**From:** Paul Hackney [REDACTED]  
**Sent:** Monday, 12 December 2016 3:38 PM  
**To:** DPE PS coastal Mailbox  
**Subject:** Coastal Management SEPP - Wetland Map Amendments  
**Attachments:** Coastal Management SEPP Wetland Mapping Amendments - Macarthur St to James Ruse Dr.jpg; Coastal Management SEPP Wetland Mapping Amendments - James Ruse Dr to Camellia Peninsula.jpg; Coastal Management SEPP Wetland Mapping Amendments - Eric Primrose Reserve.jpg; Coastal SEPP Wetlands Map Amendments - Ermington Bay.tif; Mangroves - Macarthur St to Parra Ferry Terminal.jpg; Mangroves - James Ruse Dr to Carlingford Railway Bridge.jpg; Mangroves - James Ruse Dr to Macarthur St.jpg

Please find attached and below suggested changes to the coastal zone mapping for the City of Parramatta LGA. We are also currently considering whether to submit a response to the text of the draft coastal SEPP.

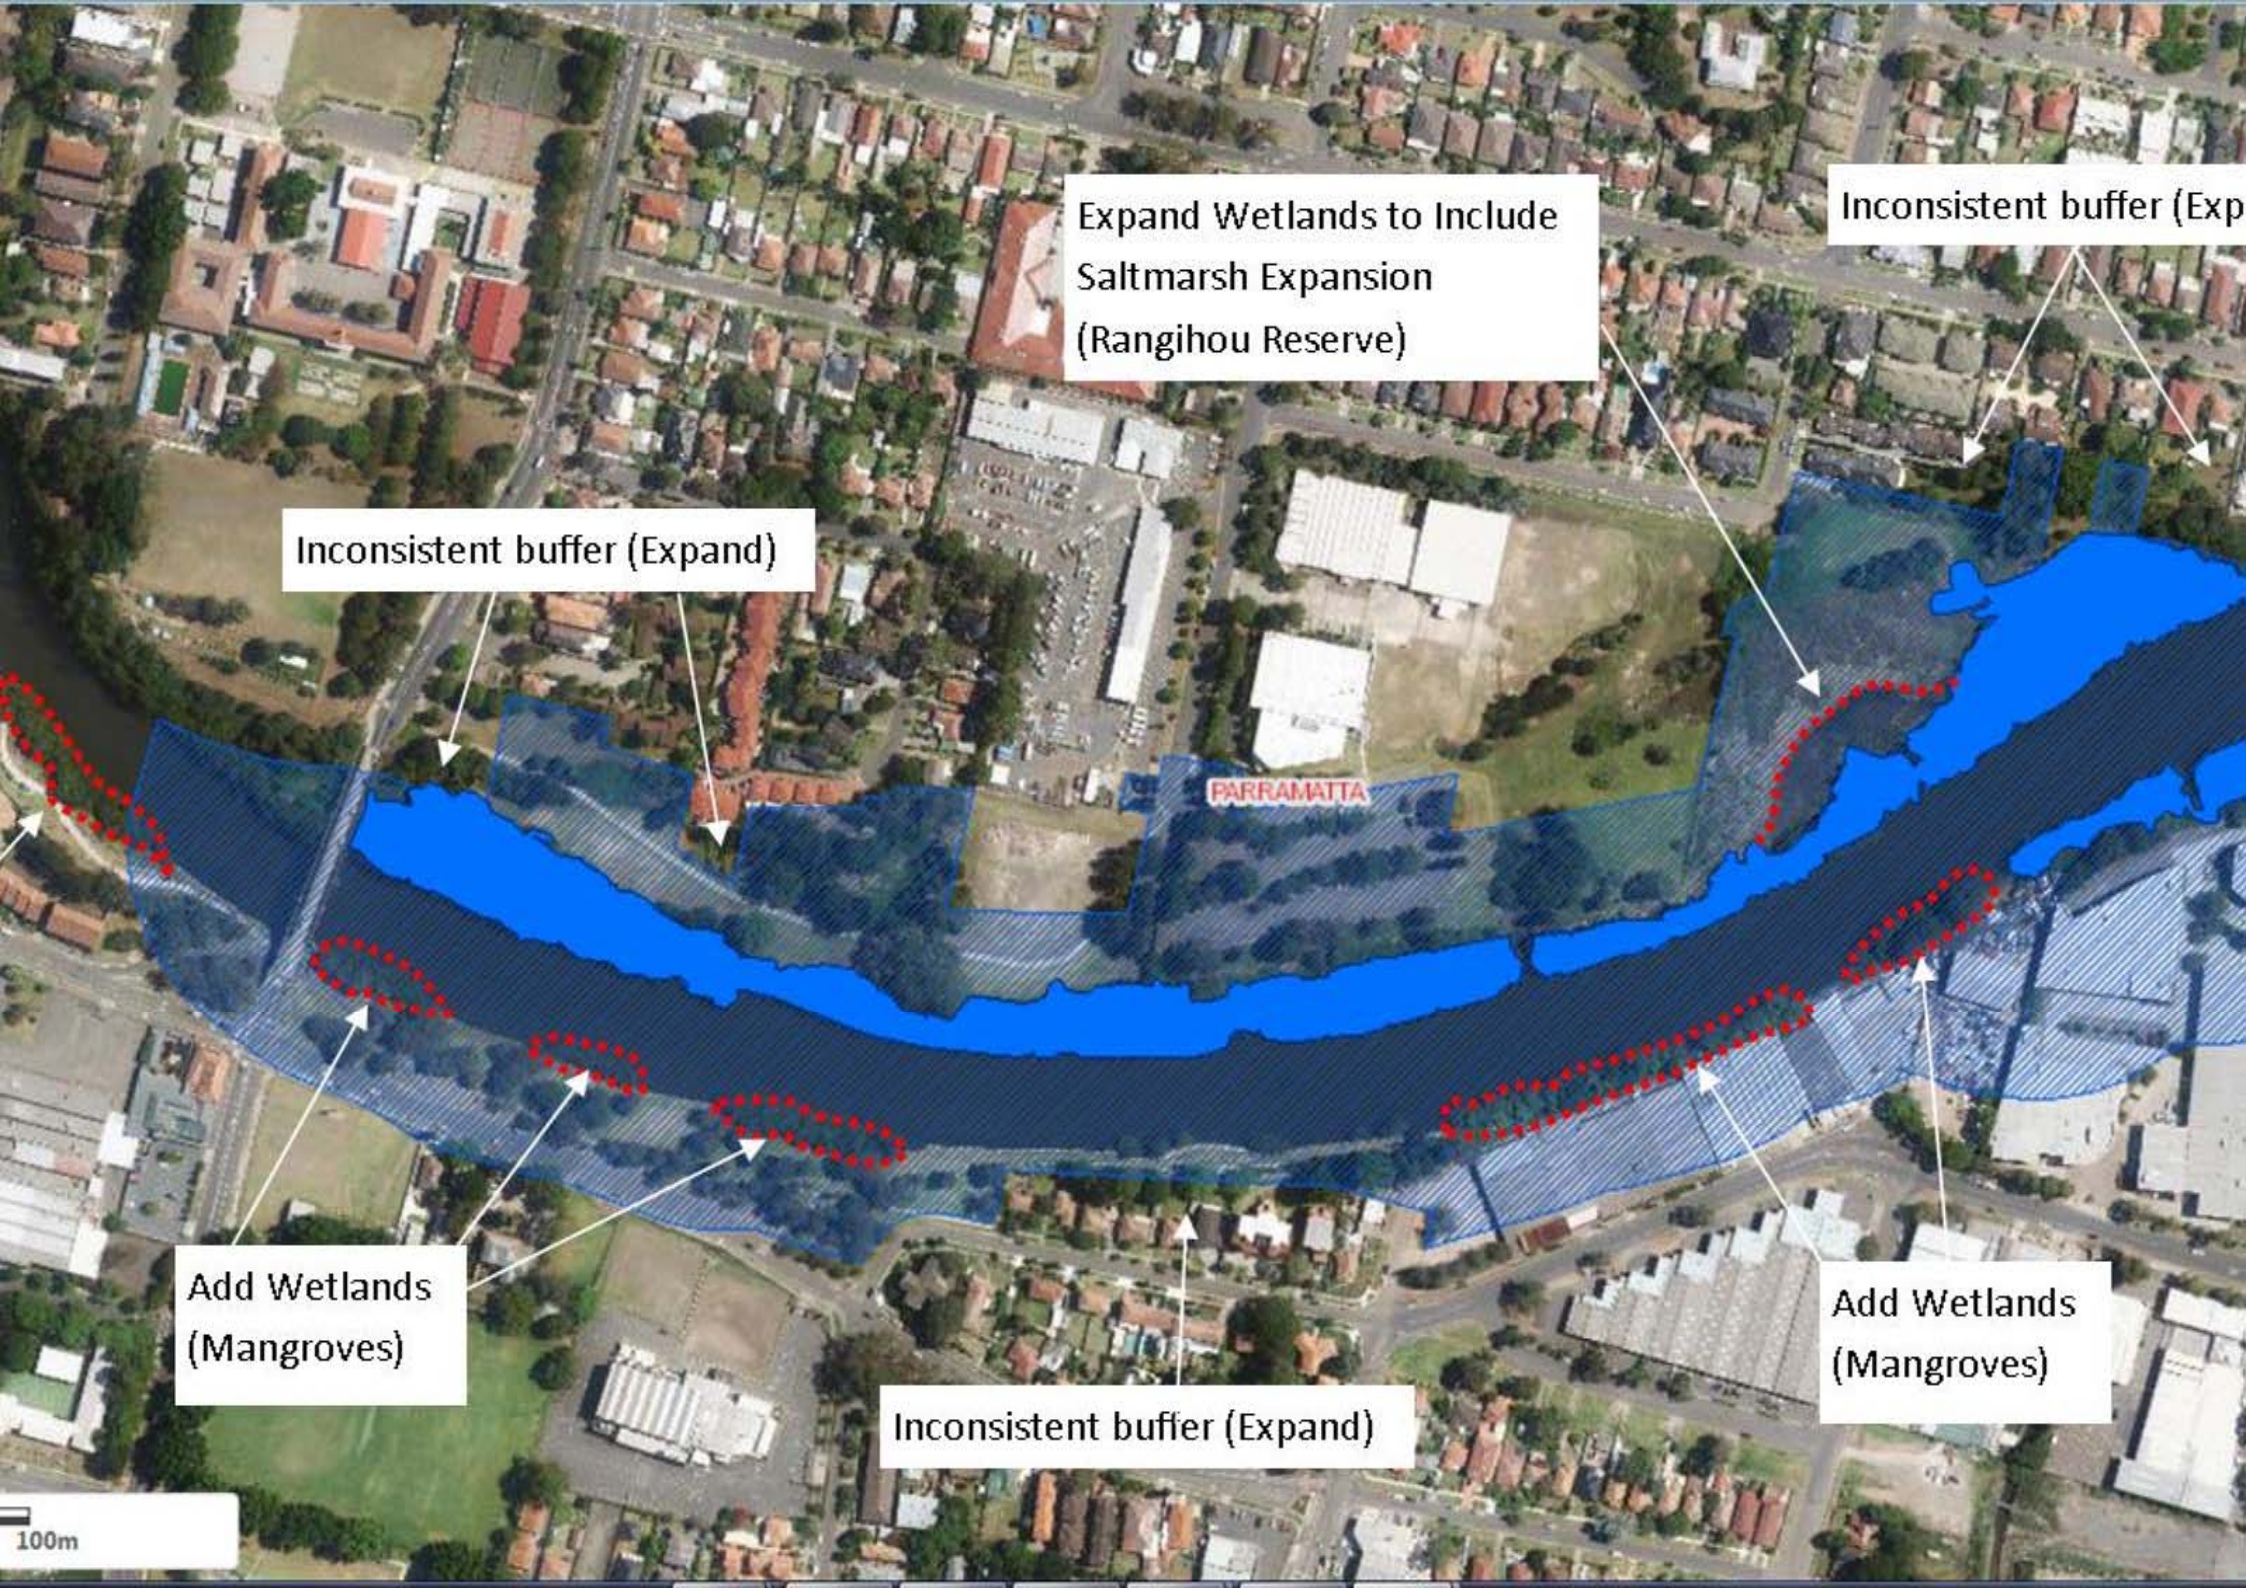
The current mapping has excluded patches of mangroves (some including saltmarsh) in the upper reaches of the tidal area and needs to be updated to ensure that these are captured (see attached maps & photos).

This has generally been applied as a 100m buffer (consistent with the principle applying to 'Coastal Use Areas' and 'Coastal Environment Areas'; however there are a number of inconsistencies in the section of Parramatta River between James Ruse Driver and Macarthur Street (see attached map). This buffer needs to be applied consistently to all wetlands within the City of Parramatta LGA.

Council has successfully expanded the area of saltmarsh in Rangihou Reserve in partnership with previous NSW Government Grant funding. Coastal Wetlands mapping in this reserve needs to be amended to include the saltmarsh expansion area (see attached map).

Expand Wetlands to Include  
Saltmarsh Expansion  
(Rangihou Reserve)

Inconsistent buffer (Expand)

Inconsistent buffer (Expand)

Add Wetlands  
(Mangroves)

Inconsistent buffer (Expand)

Add Wetlands  
(Mangroves)

Add Wetlands  
(Mangroves)

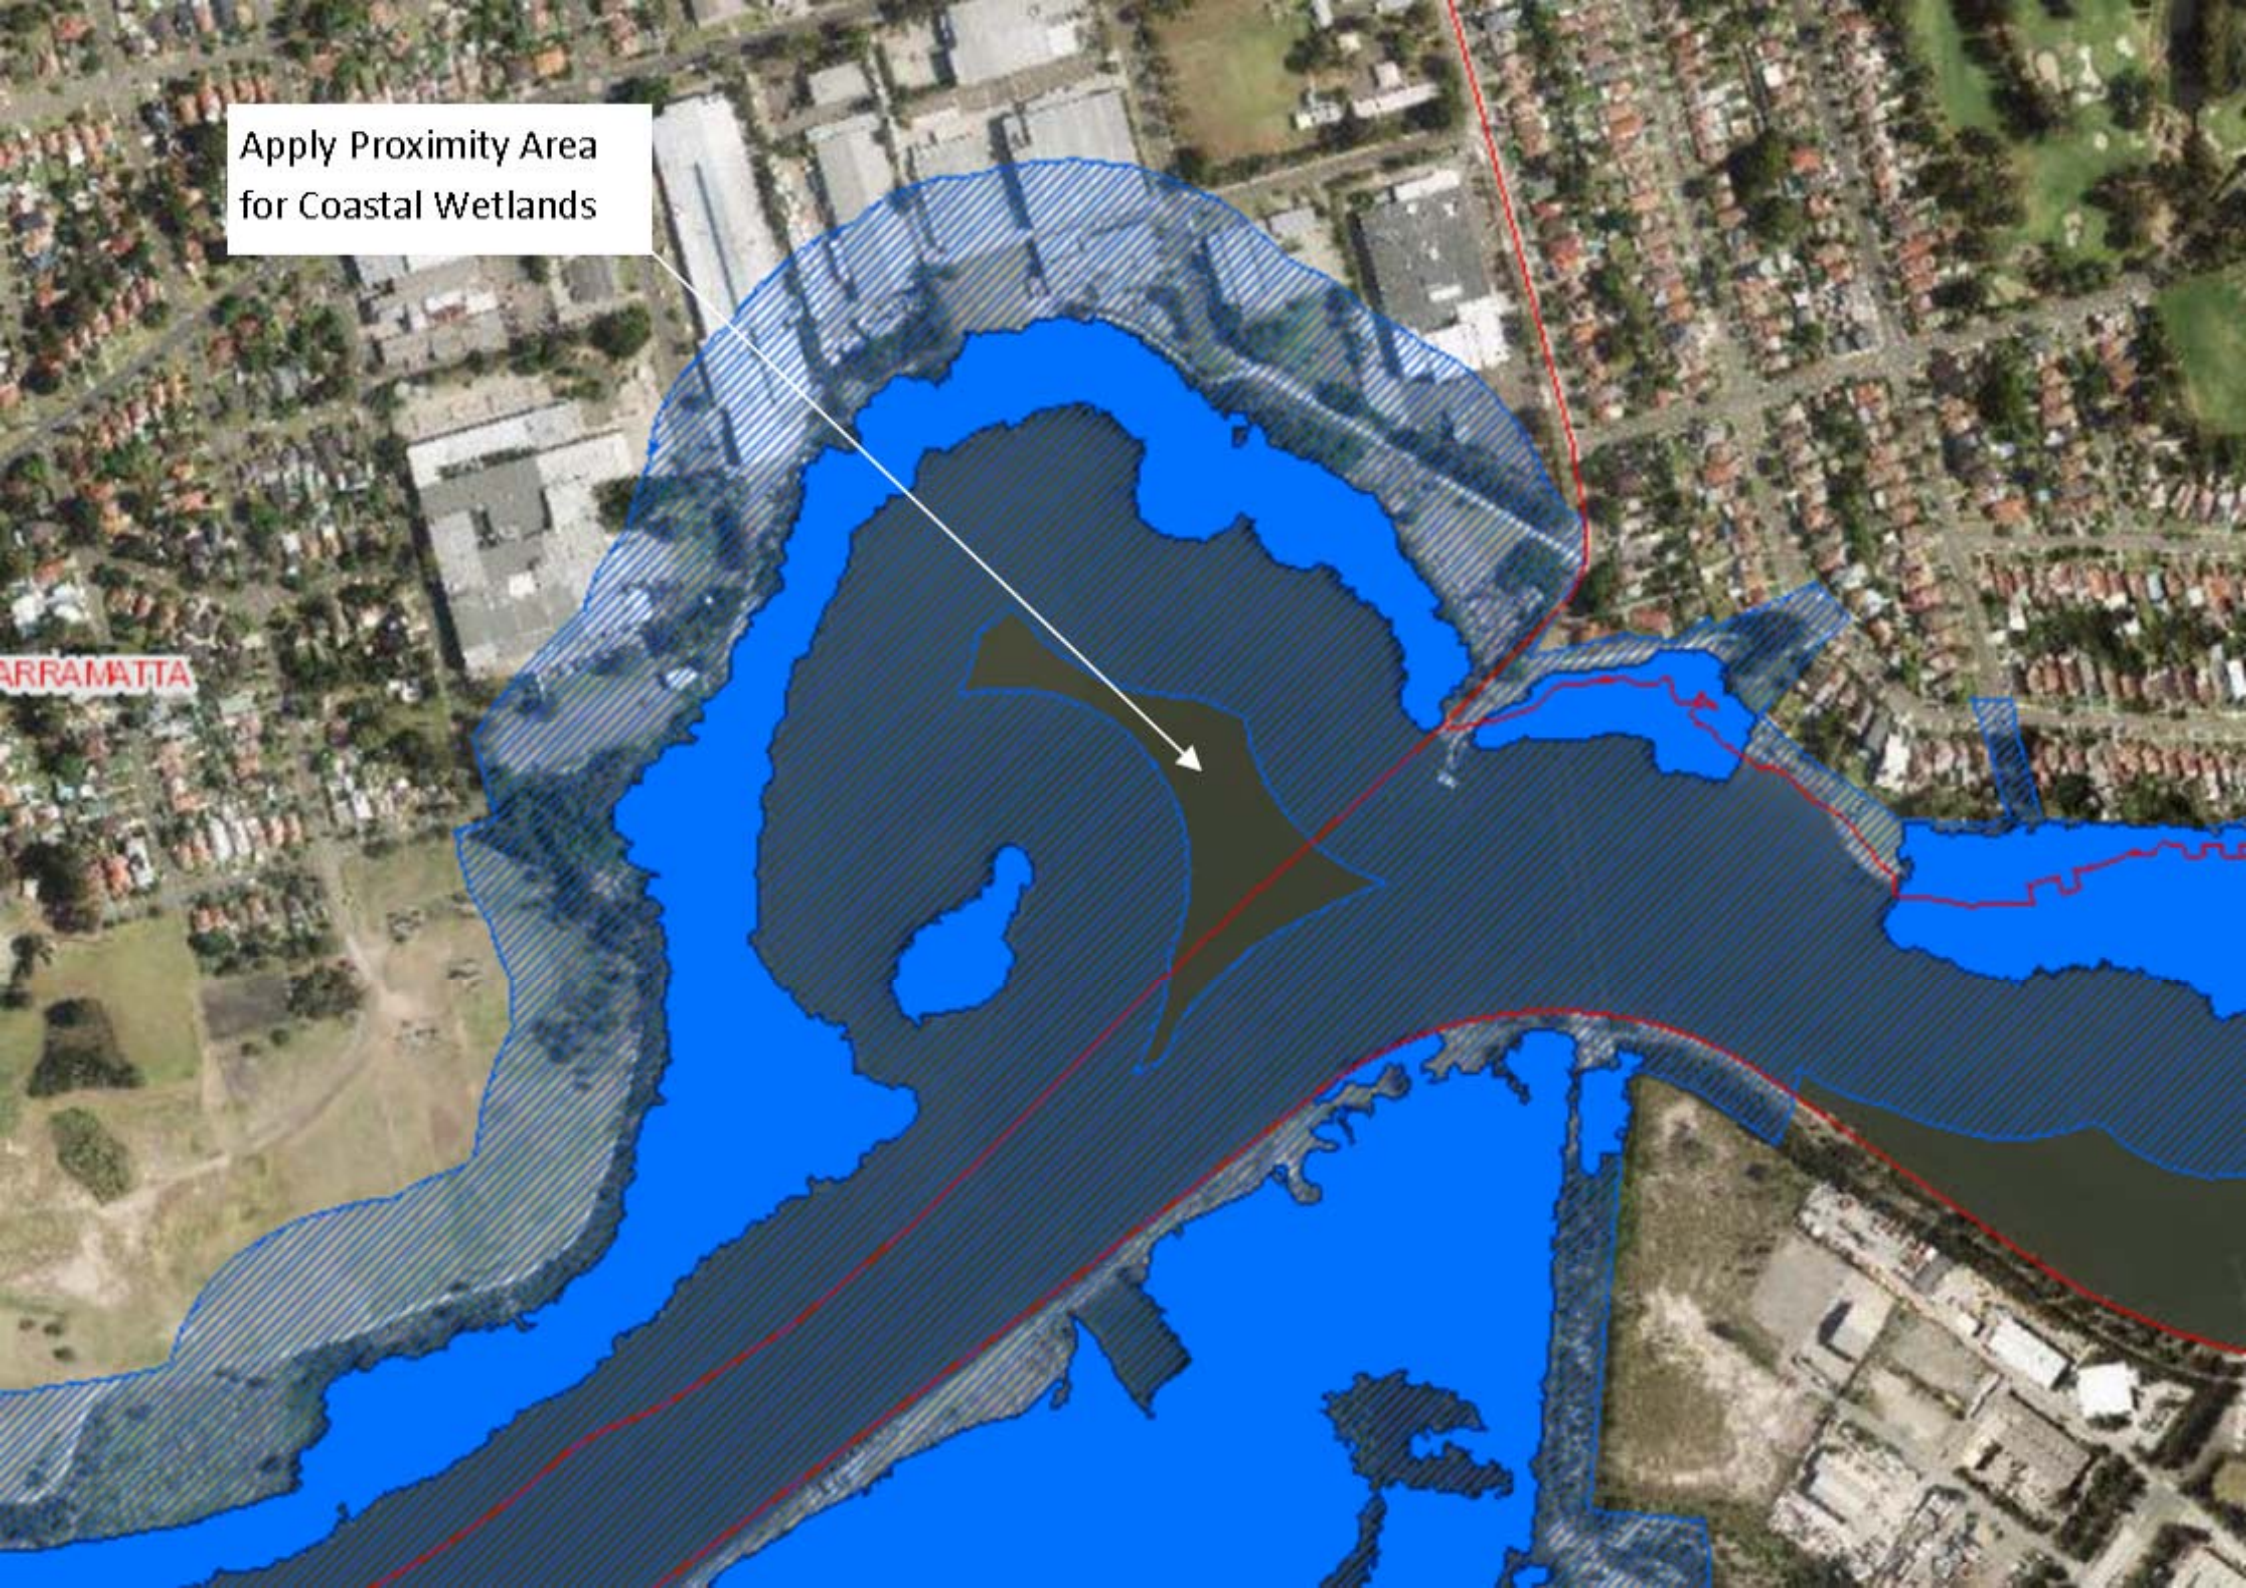
Ermington Bay contains intertidal mudflats that provide important estuarine habitat for wading and non-wading birds and the 'Proximity Area' should apply to the entire bay (see attached map).

Add Wetlands  
(Mangroves)

Apply Proximity Area  
for Coastal Wetlands
